Access Compliance Report

Public Rights-of-Way

(Curb Ramps)

Intersection ID: 47581	Main Street: ROCK_ISLAND_RD	Cross Street: GLENBURN_LN	Location: NW
ADA ID: EB4D34BA78FE	Ramp Type: PerpDiag	Initial Pass/Fail: Fail	Overall Compliance: No
		Severity Score: 12.5

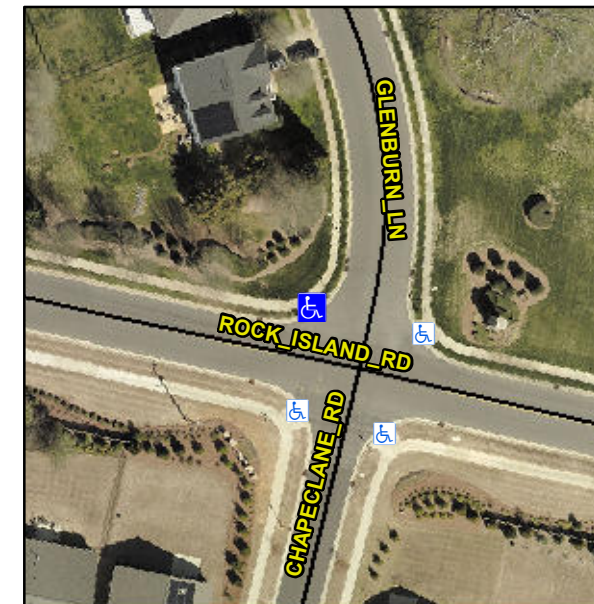
Not Found, R304.2.2

Compliance	Description	Data	Compliance	Description	Data
N/A	Ramp Length (in)	49.0	No	Ramp Slope (%)	10.6
Yes	Ramp Width (in)	48.0	Yes	Ramp XSlope (%)	0.0
N/A	Flare Type LT	N/A	N/A	Flare Type RT	N/A
N/A	Flare Slope LT (%)	N/A	N/A	Flare Slope RT (%)	N/A
N/A	Flare Traversable LT?	N/A	N/A	Flare Traversable RT?	N/A
N/A	Landing Length (in)	N/A	N/A	DWS Provided?	N/A
N/A	Landing Width (in)	N/A	N/A	DWS Contrast?	N/A
N/A	Landing Slope (%)	N/A	N/A	DWS Length (in)	N/A
N/A	Landing X Slope (%)	N/A	N/A	DWS Full Width?	N/A
N/A	Landing Curb? (Y/N)	N/A	N/A	DWS Offset (in)	N/A
N/A	Shared Landing?	N/A			
N/A	Gutter Ponding?	N/A	N/A	Gutter Slope (%)	N/A
N/A	Gutter Lip Ht (in)	N/A	N/A	Gutter X Slope (%)	N/A
N/A	Painted X Walk1?	No	N/A	Painted X Walk2?	No
	X Walk 1 Direction	To SW		X Walk 2 Direction	To SE
N/A	X Walk 1 Width (in)	N/A	N/A	X Walk 2 Width (in)	N/A
	X Walk 1 Slope (%)	1.5		X Walk 2 Slope (%)	1.0
	X Walk 1 X Slope (%)	2.7		X Walk 2 X Slope (%)	1.4

Remove & Replace Curb Ramp With Two New Directional Ramps or Equivalent.
